## Request for Class II Permissive Change

## FCC ID: VG8XM720CYY-PM

Please be notified that we, the undersigned, Guangdong Midea Kitchen Appliances Manufacturing Co.,Ltd. declare that the reasons for this class II permissive change are as below:

Original Mother board bottom view

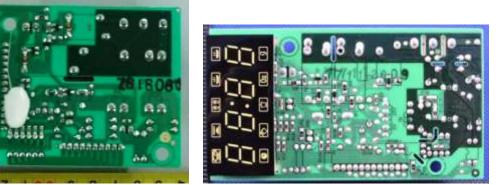
1. Changed Mother board as below.

New mother board has the same circuit fuction and input/output power with original, difference of between them is changed linear transformer to switching power supply.
